JUNCTION LANDING

Second Design Review Recommendation
4417-4423 42ND AVE. SW
Southwest Design Review Board - SDCI #3026661

April 5, 2018

Exterior Elements & Finishes

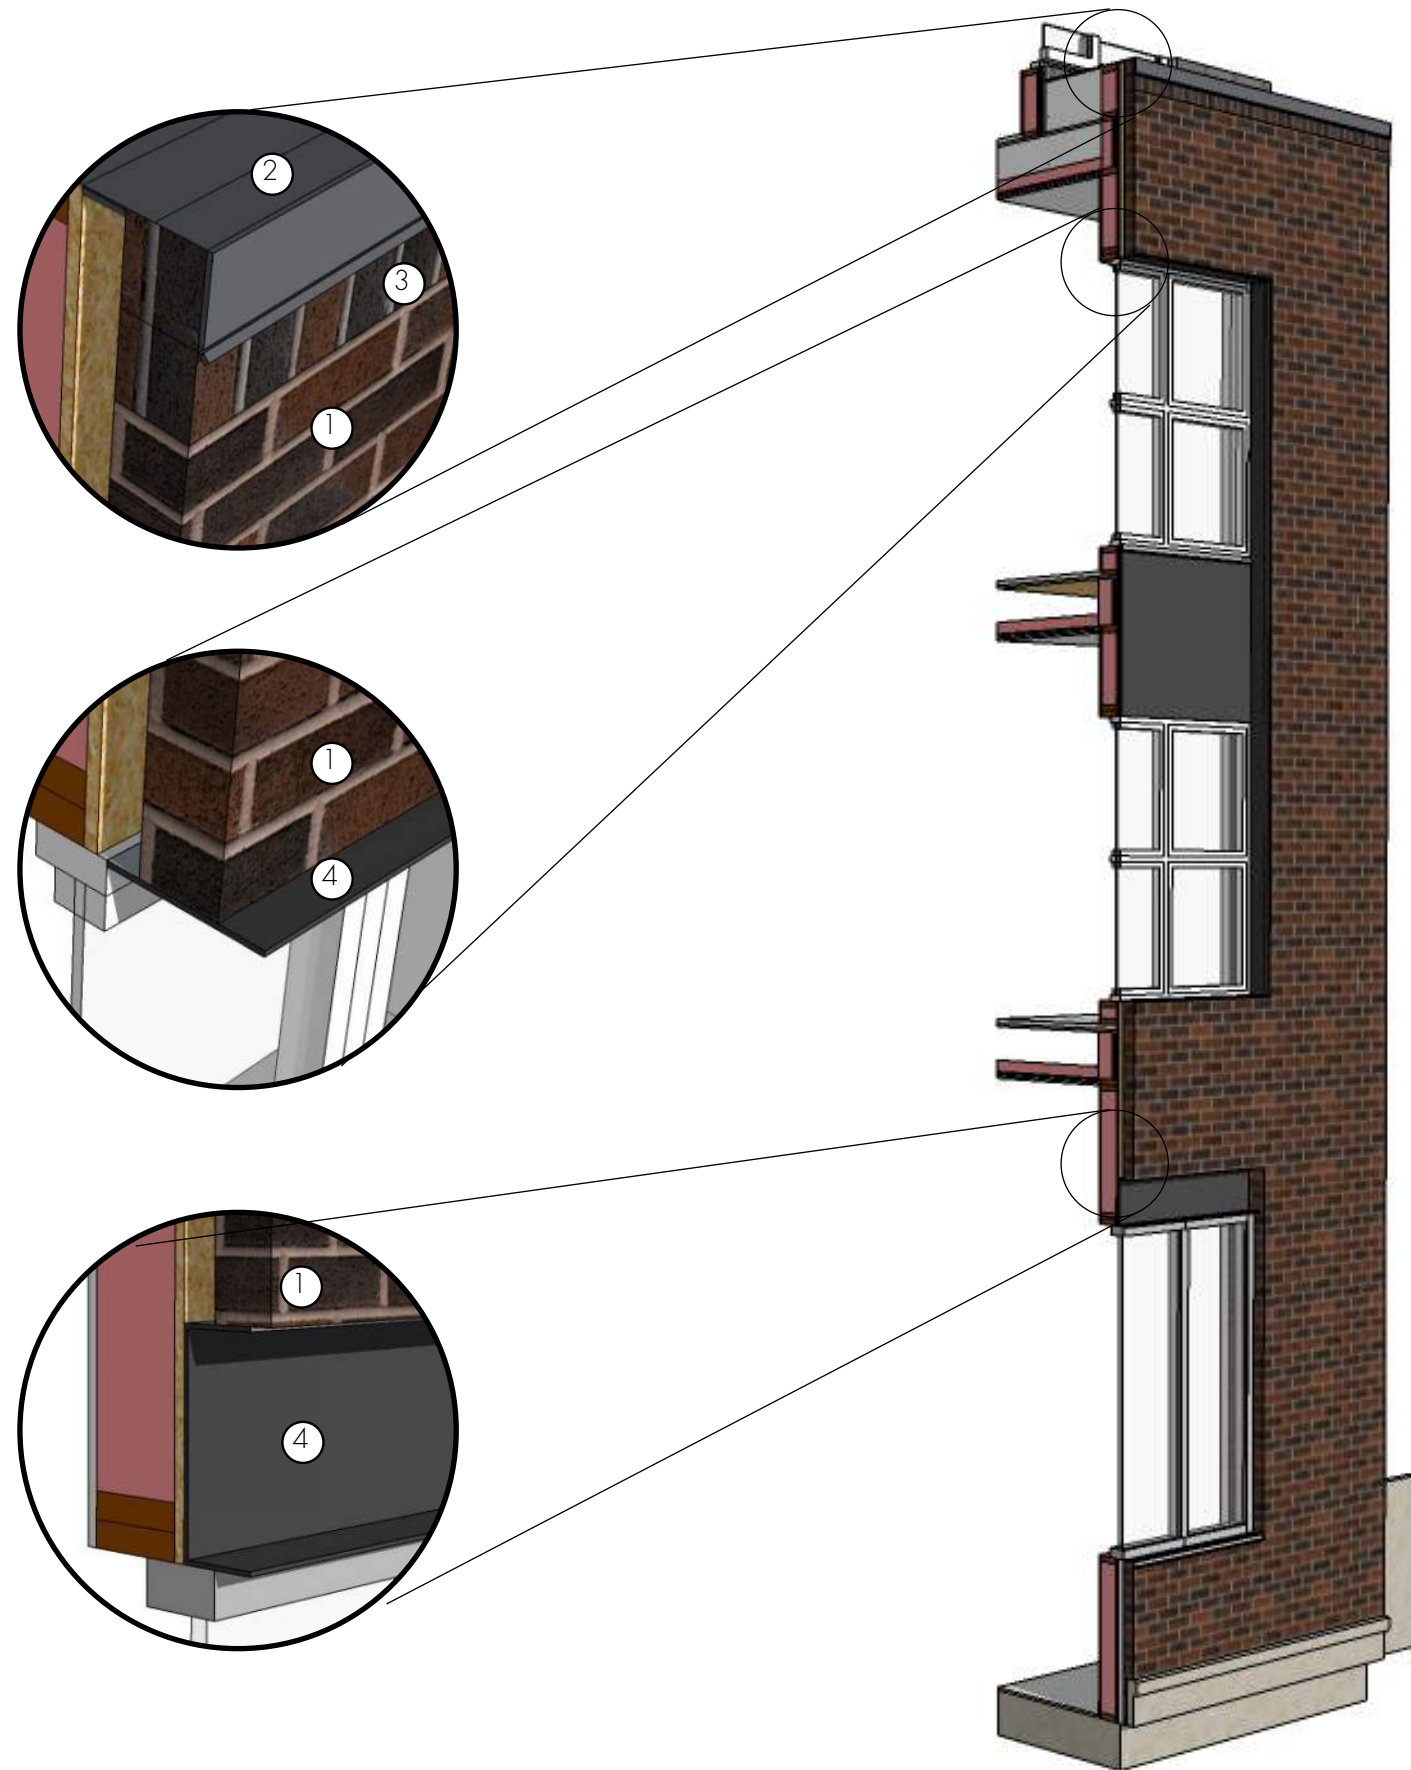
- i. The Board approved of the way the east façade was broken up and how the bays were expressed out of a masonry element. The Board recommended that concept (bays expressed out of a masonry element) be brought around the entirety of the building to create a cohesive design concept. (DC2-B)
- ii. The Board recommended changes to resolve the material application above and below the third floor horizontal band. (DC2-B)
- iii. The Board appreciated how the metal detailing was applied to the first floor live/work units and recommended extending that detailing throughout the brick. (DC2-B)

We carried over the break shape metal detailing above the live works throughout the brick bay by expressing it in the transitions between window and brick and as a metal cap on the soldier course to express a modern brick treatment. Please see page 20 for detailing proposed in the brick building.

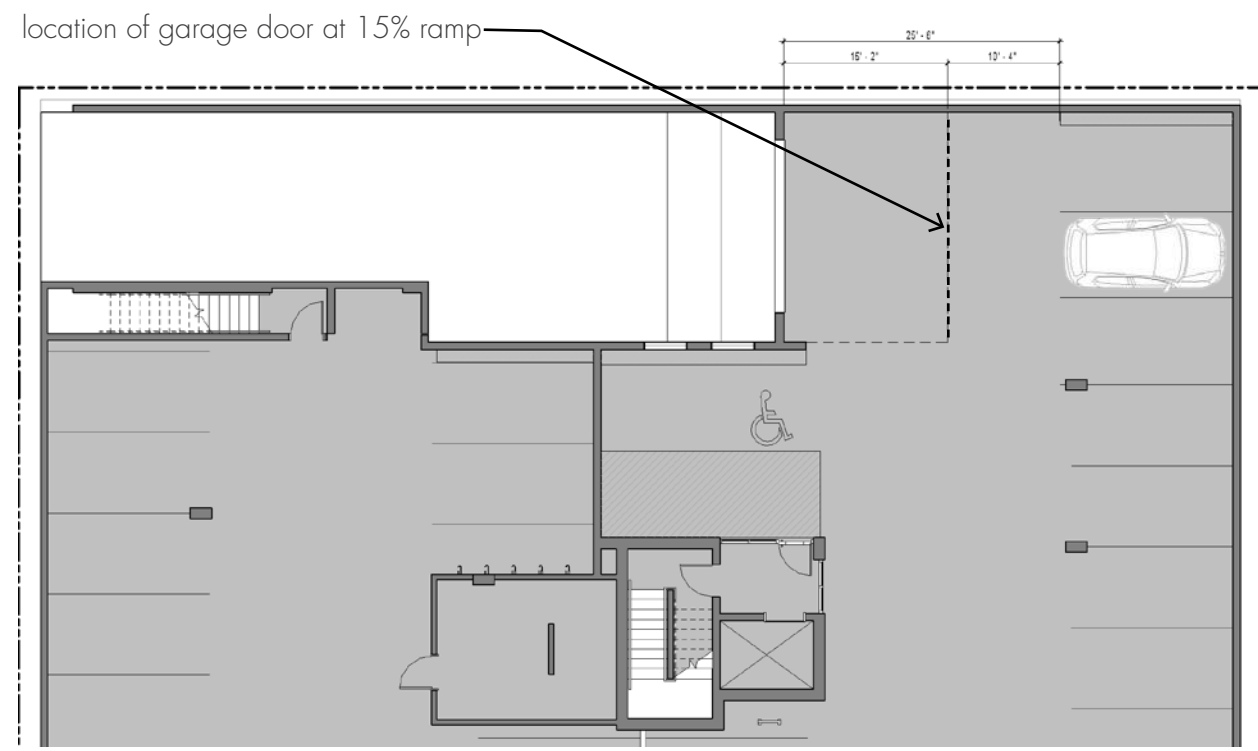
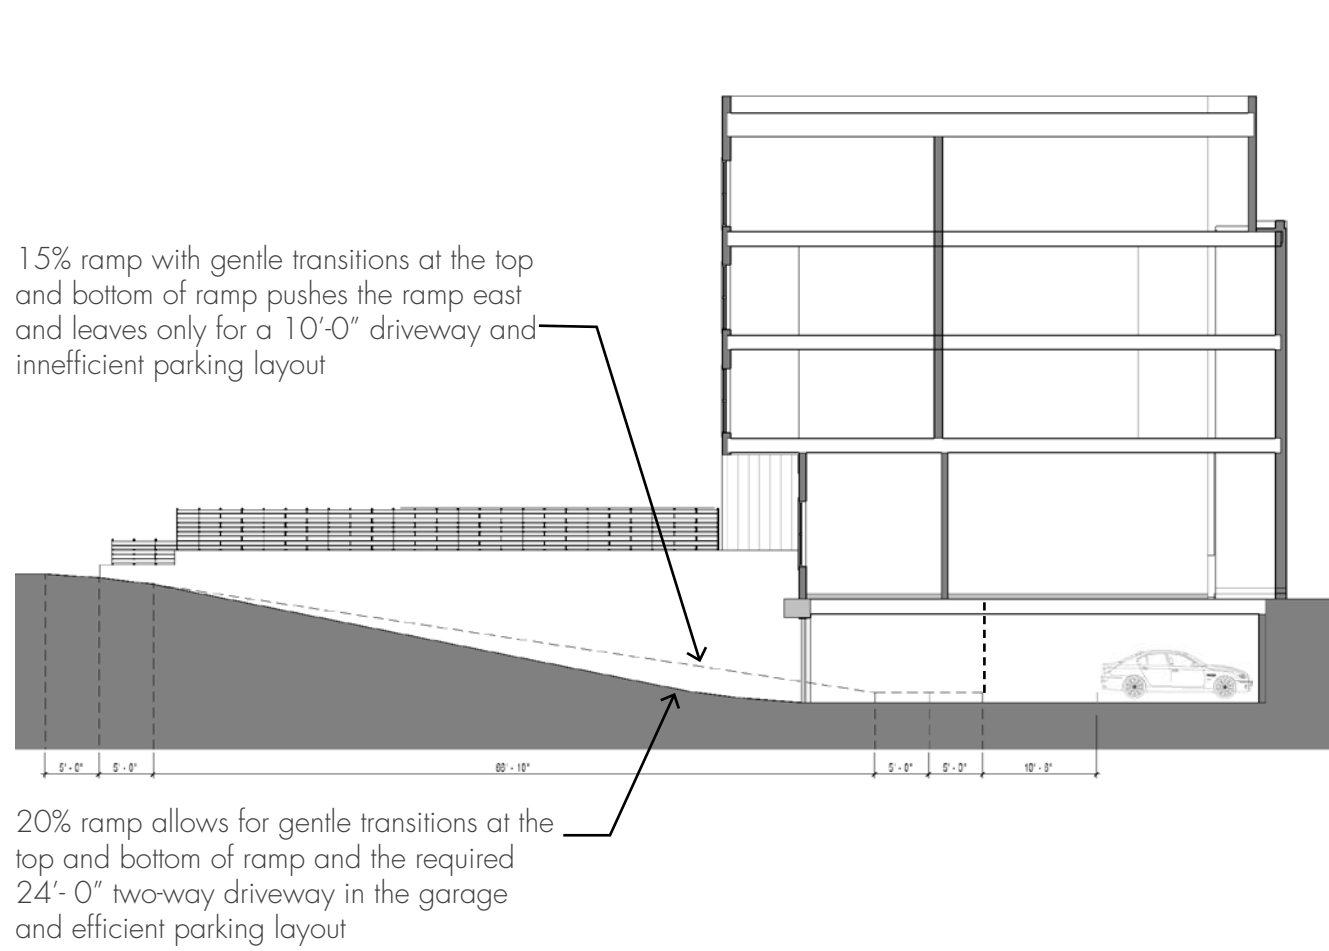
b. The Board appreciated the applicant's approach to the green roof concept and did not want to see any of the green roof area reduced. However, the Board found the proposed rooftop landscaping response did not push the limits of creating a substantial tree/flower habitat on the roof. The Board recommended that the rooftop landscaping be designed to further enhance the design concept of a pollinator pathway. This could include more flowering species such as wildflowers, and incorporate planters along the building's edge to create a more significant eco system that would act as a pollinator pathway. (DC4-D)

Response: In our revised version, we introduced more variation in the landscaping surrounding the roof deck. A larger growth green roof medium at the roof edges create a secondary texture besides the standard sedum trays. The entire roof deck is surrounded by landscaping.

We have also rearranged the roof deck extent and utilized the bioretention planters, decorative planters and urban farm to create separate zones of intimate seating areas.

Flowering sedums that can attract bees and butterflies are being proposed to provide variation and color with the passing seasons. Please refer to page 25 for proposed plantings.

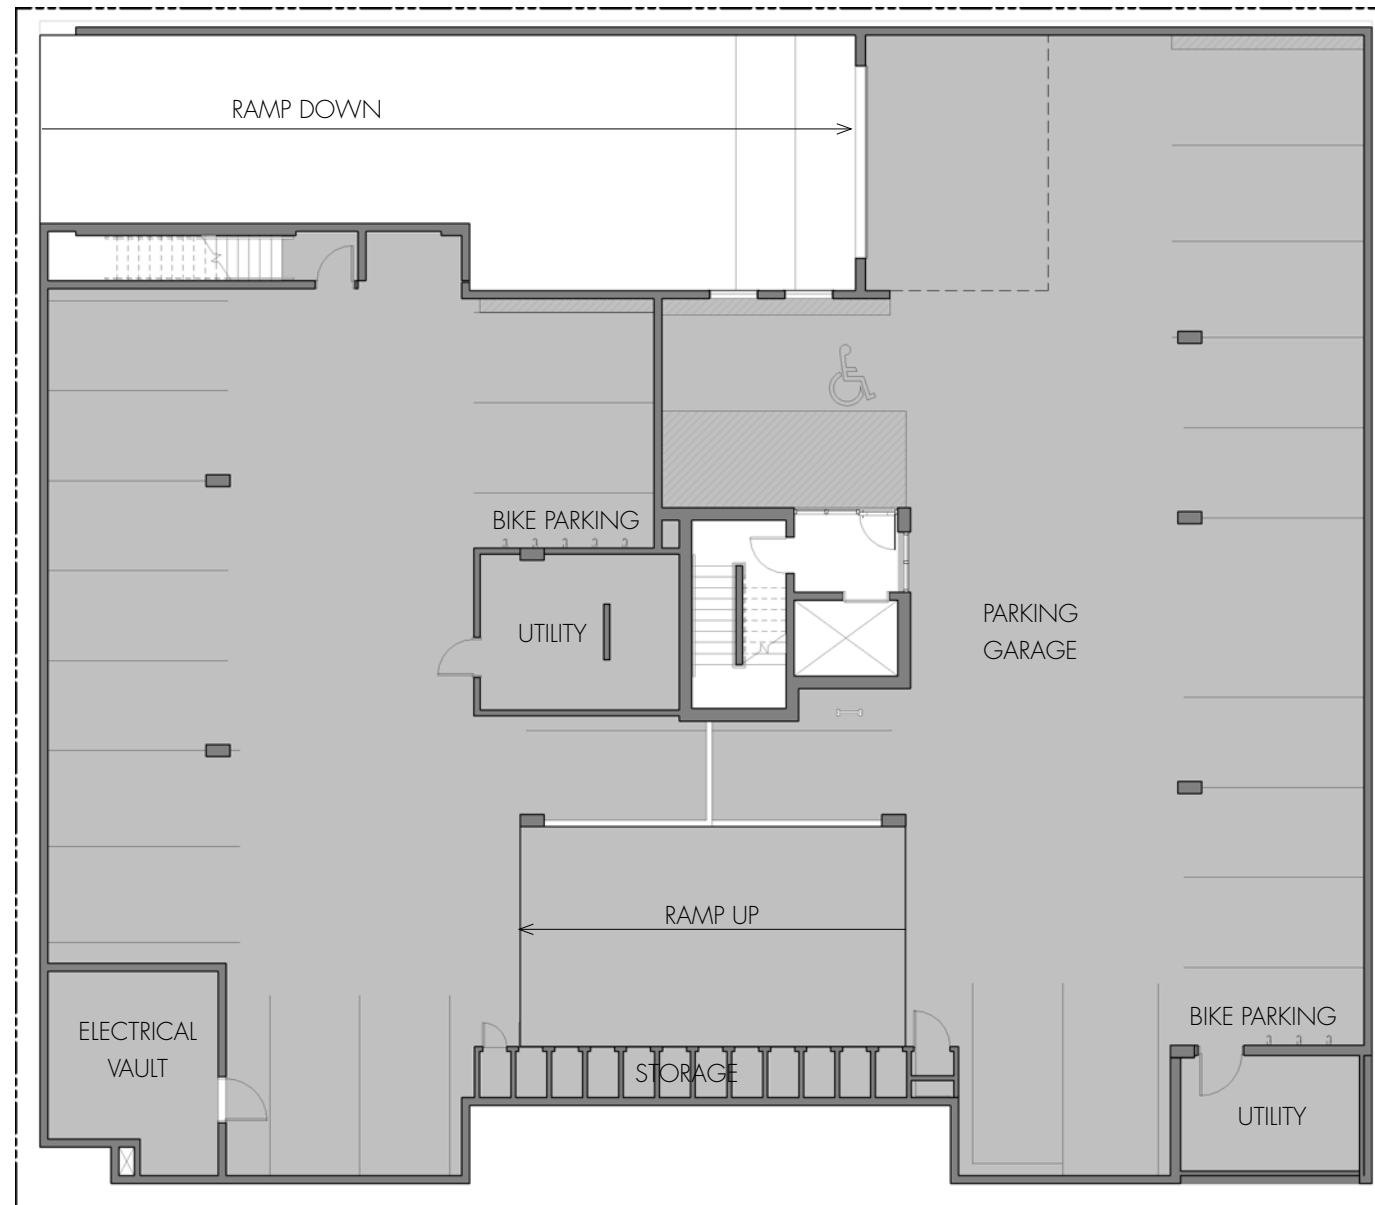
A. Acknowledging public concern, the Board would like to review additional information on the driveway access including a design for the fencing/railing being considered for safety purposes and how this will be aesthetically pleasing to the neighboring property. (DC1-B)

B. The Board had concerns with the driveway interaction with the alley, for safety and visual impacts, as the driveway will not be at the grade of the alley but downgrade, creating a void which will be very much present along the alley. The Board requested details of the building treatment of the walls on the east and south sides of the driveway to address the potential blank facade. (DC1-C)

MUP Response: We also acknowledge the desire for privacy and safety to the neighbor to the North and provided screening from the garage ramp in the form of an elegant wood and metal fence (setback from the property line to increase vehicle and pedestrian visibility), that announces the driveway from the alley and provide privacy to the resident's yard. The East and South side of the driveway were carefully designed like the rest of the building, paying attention to the break in massing through texture and color and providing a fair amount of glazing so that it is not a blank facade facing the neighbor to the north but also private enough due to the distance created by the ramp.
